City of Detroit
**City Engineering Division, Department of Public Works
Survey Bureau**

NOTICE OF PROPOSED CHANGE IN PROPERTY

Petition: x931

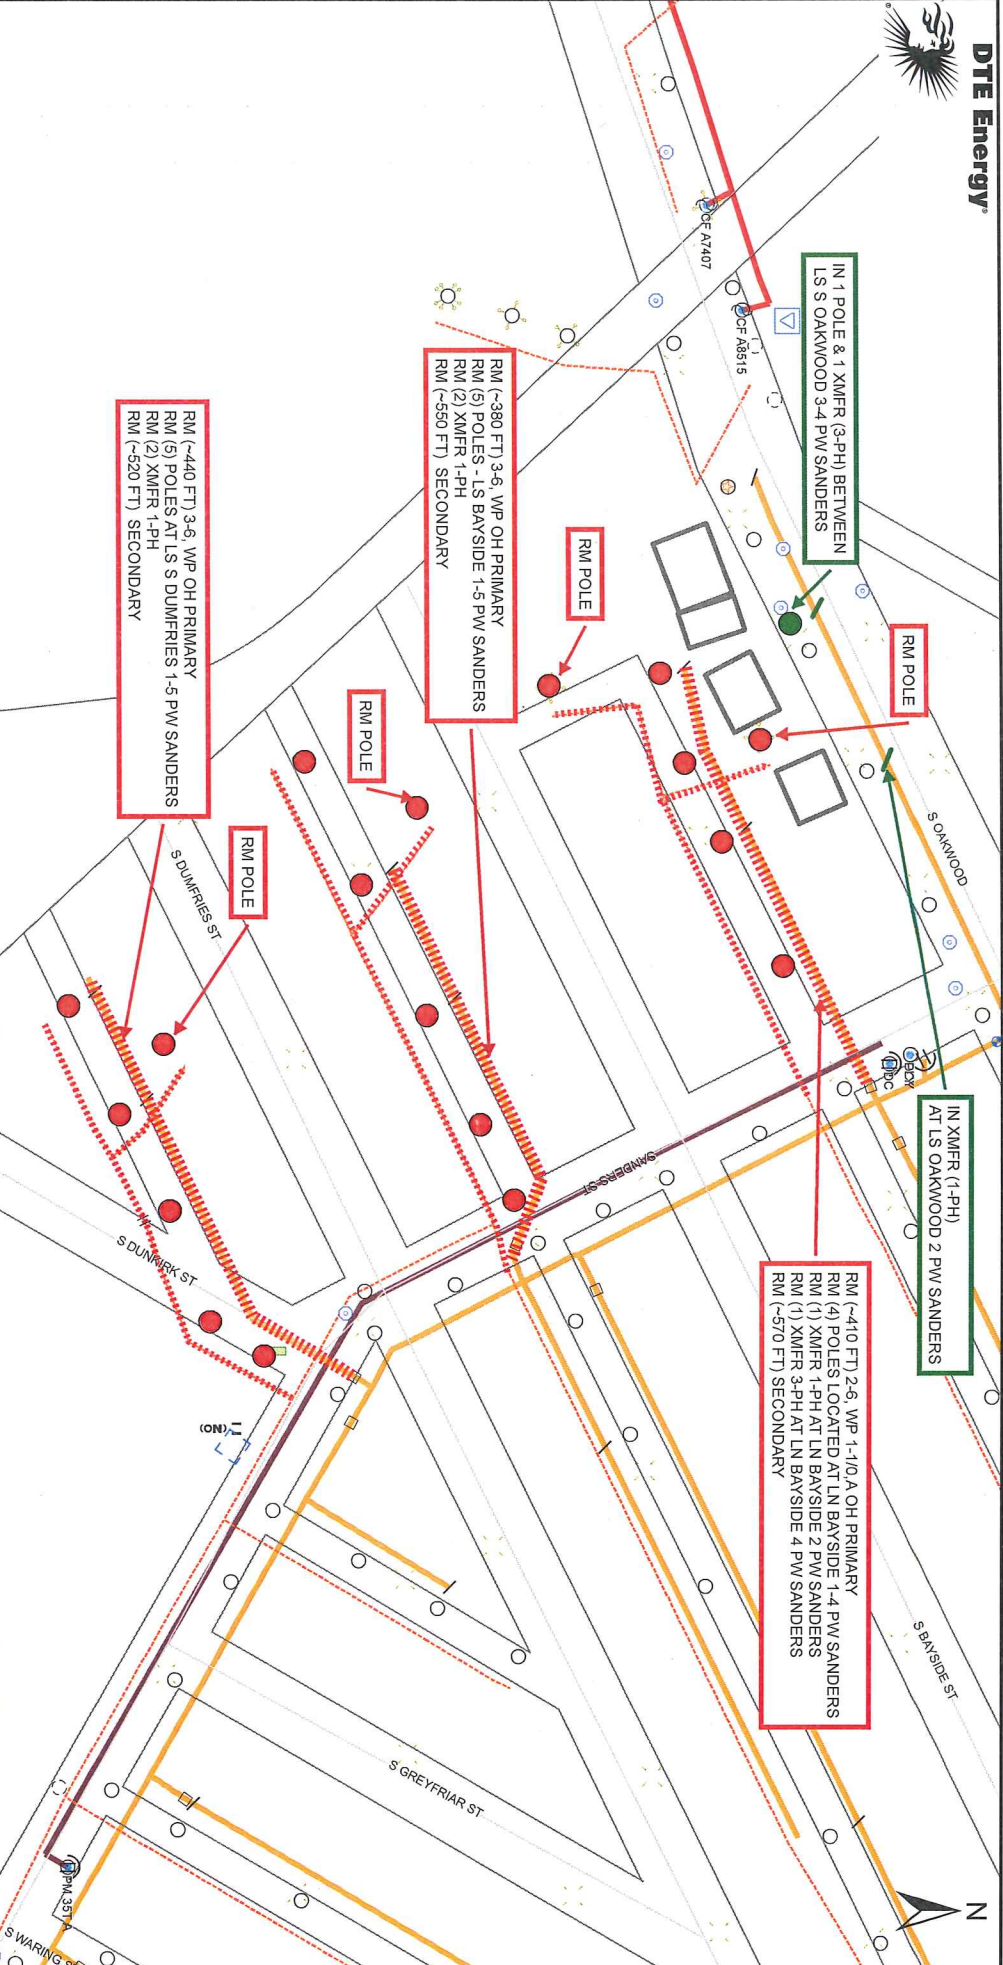
Involved; the nature of our services and the estimated costs of removing and/or rerouting such services are: \$92,148.98

IN 1 POLE & 1 XMFR (3-PH) BETWEEN LS S OAKWOOD 3-4 PW SANDERS

RM POLE

RM (~380 FT) 3-6, WP OH PRIMARY
RM (5) POLES - LS BAYSIDE 1-5 PW SANDERS
RM (2) XMFR 1-PH
RM (~550 FT) SECONDARY

RM POLE

RM (~440 FT) 3-6, WP OH PRIMARY
RM (5) POLES AT LS S DUNPRIES 1-5 PW SANDERS
RM (2) XMFR 1-PH
RM (~520 FT) SECONDARY

RM POLE

IN XMFR (1-PH) AT LS OAKWOOD 2 PW SANDERS

RM (~410 FT) 2-6, WP 1-1/0, A OH PRIMARY
RM (4) POLES LOCATED AT LN BAYSIDE 1-4 PW SANDERS
RM (1) XMFR 1-PH AT LN BAYSIDE 2 PW SANDERS
RM (1) XMFR 3-PH AT LN BAYSIDE 4 PW SANDERS
RM (~570 FT) SECONDARY
